TECHNICAL BULLETIN

FOR TARGET MARKET ROOFING

Subject: Lightning Protection

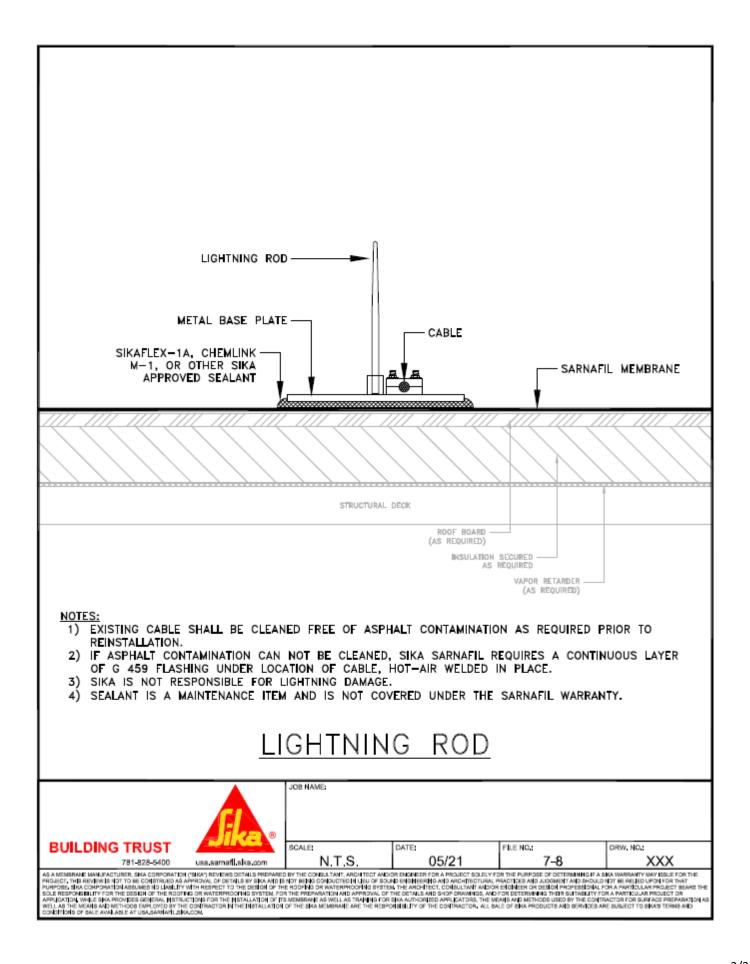
Regarding the attachment of the lightning protect rods to our membrane, starting immediately, we will accept the use of either Sikaflex 1a or Chem-Link M-1 Sealant to adhere the lightning protection direct to the roof membrane, we will no longer require a separator layer. Please see attached detail.

LIGHTNING ROD BRACKET

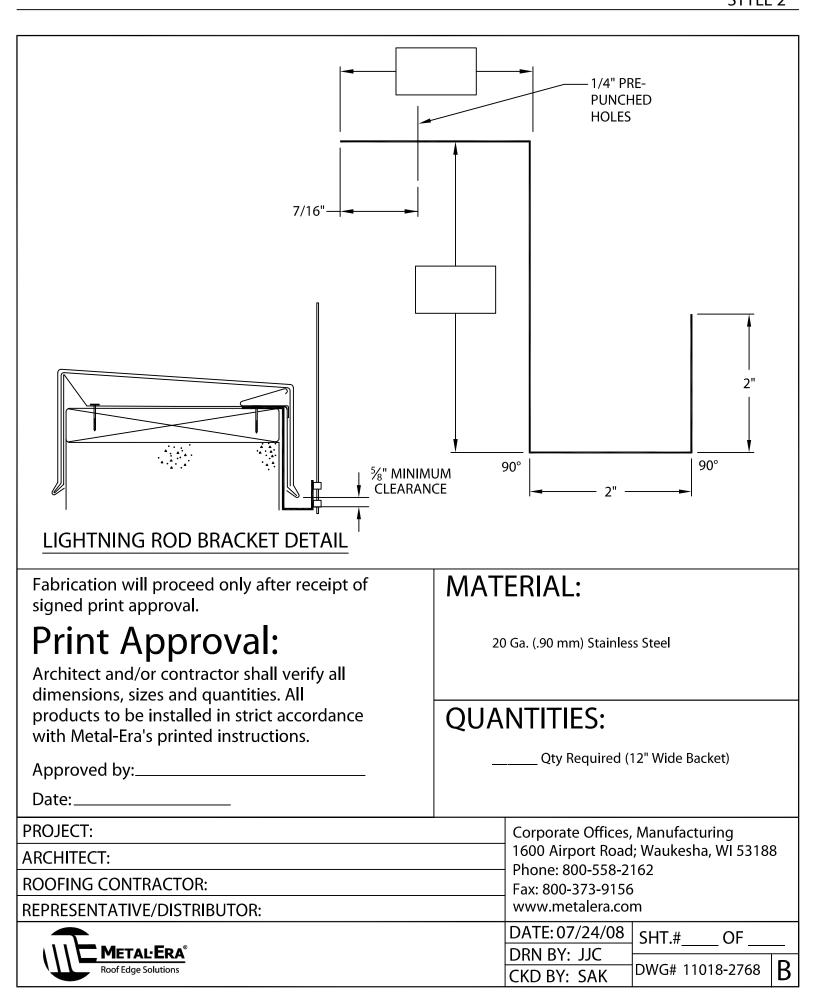
If the lightning protection design shows attachment to the metal edge, the supplier of the edge system must be informed and provide input as to how this may be accomplished. Metal Era has three (3) details that can be used to not void the warranty, please see the following Metal Era details.
